Service Bulletin #165

SUBJECT: OVERHEAD ROCKER OIL FEED LINES ON ALL A50 AND A65 MODELS

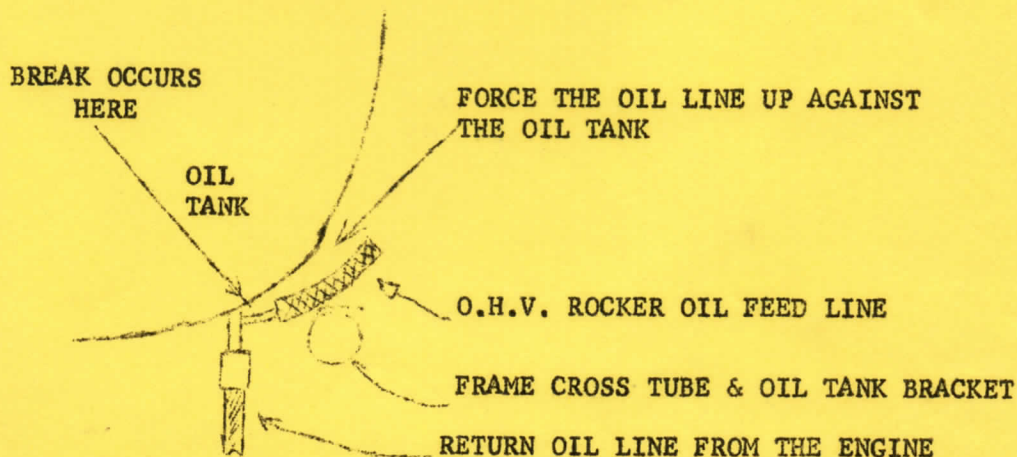
We have received reports that a number of rocker box oil feed lines have broken off at the oil tank fitting.

If this oil feed line to the rocker box is too close to the frame bracket, the movement of the rubber mounted tank is apt to cause it to break.

You must inspect all the machines you have sold and the ones you have on your Showroom Floor and if the rubber connector touches the frame bracket you must force it up close against the oil tank as far away as possible from the frame bracket.
